UNITED STATES PATENT AND TRADEMARK OFFICE

APPLICATION NO.	FILING DATE	FIRST NAMED INVENTOR	ATTORNEY DOCKET NO.	CONFIRMATION NO.
10/790,321	03/01/2004	John A Triunfo JR.	02-64	9016

Office Action Summary

DETAILED ACTION

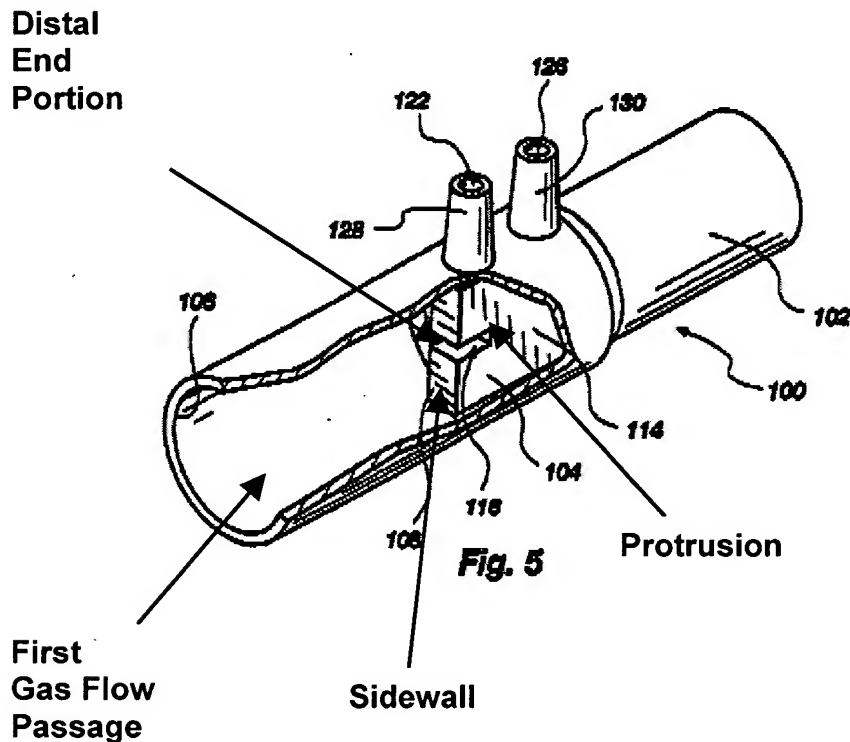
Claims 1, 2, 4, and 6-13 are rejected under 35 U.S.C. 102(b) as being anticipated by Kofoed et.al. (5,379,560).

Kofoed in an airway adaptor discloses:

- a tubular body (100) having a first gas flow passage defined therein (see illustration of Fig. 5 below); and

- a protrusion (see illustration of Fig. 5 below) extending from an interior wall of the tubular body into the gas flow passage, wherein the protrusion includes:
 - a distal end portion spaced apart from the interior wall of the tubular body (see illustration of Fig. 5 below) and
 - a second gas flow passage defined through the protrusion (116, 118, 216, 218) having an inlet at the distal end portion and an outlet at an exterior portion of the tubular body; and
 - a pair of side walls (see illustration of Fig. 5 below) disposed on the distal end portion of the protrusion such that each sidewall is generally parallel to a direction of a flow of gas through the first passage with inlet of the second gas flow passage disposed between the pair of sidewalls.

With respect to claim 6, Kofoed discloses wherein the sidewall extend along a length of the distal end portion of the protrusion such that a channel is defined between the sidewalls with the inlet of the second gas flow passage located at a bottom of the channel (see illustration of Fig. 5 above).
